**Project**  
 PROPOSED DEVELOPMENT AT  
 BALTONSBOROUGH  
 GLASTONBURY  
 SOMERSET

**Drawing Title**  
 Plots 37-41 Proposed Plans

DWG No. 4424-37-41-P01

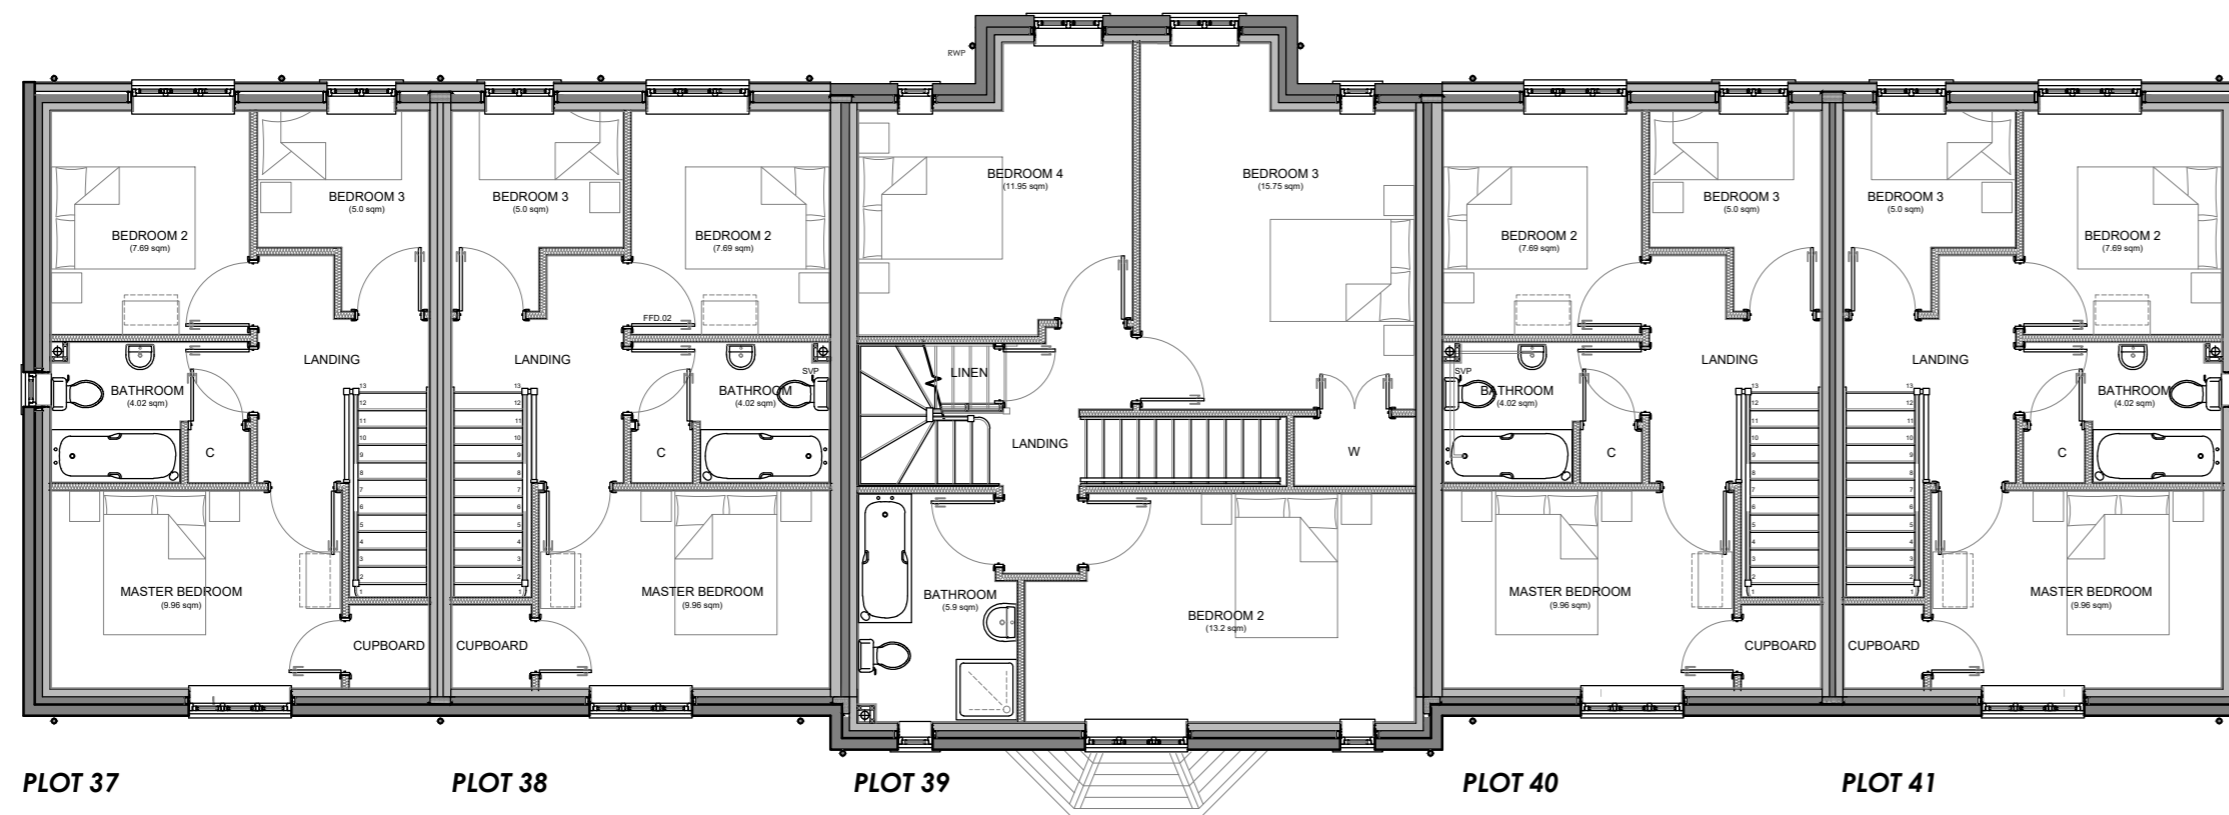
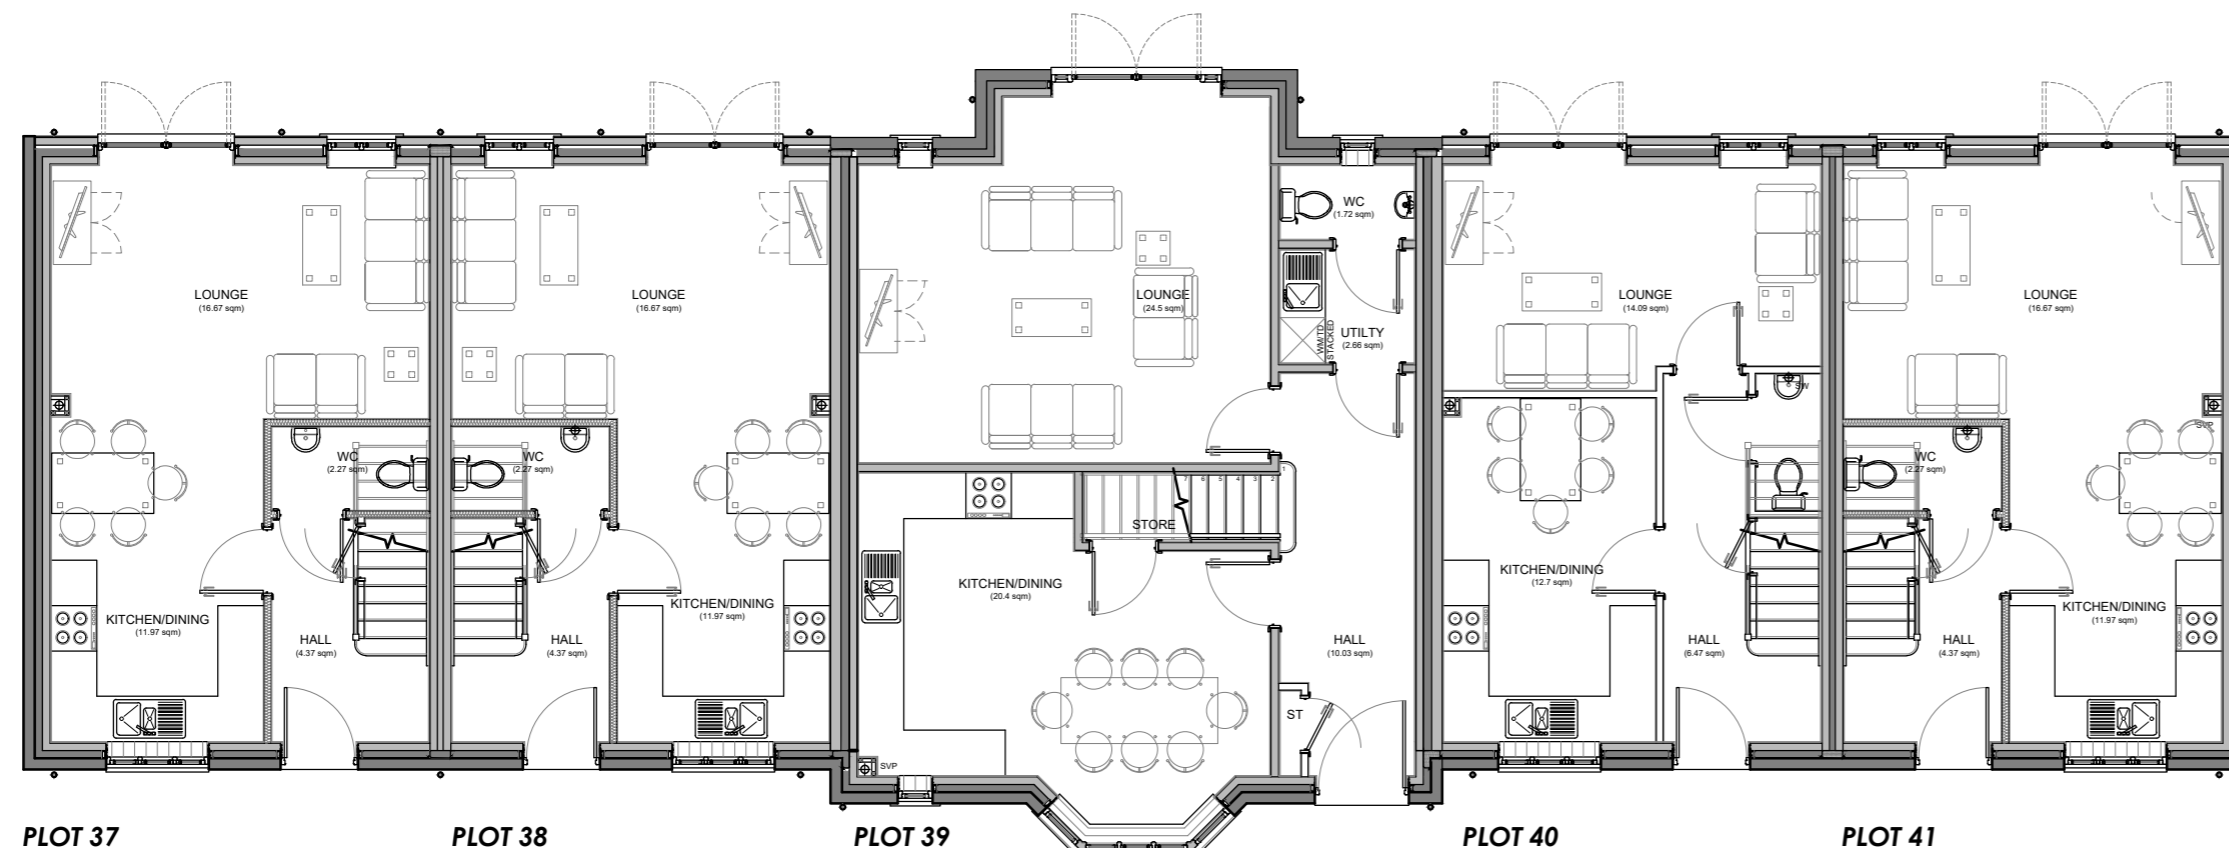
- Overall footprint sizes have remained the same, however internal layouts have been amended to better reflect the needs of the occupants in terms of kitchen sizes, bedroom configurations etc.
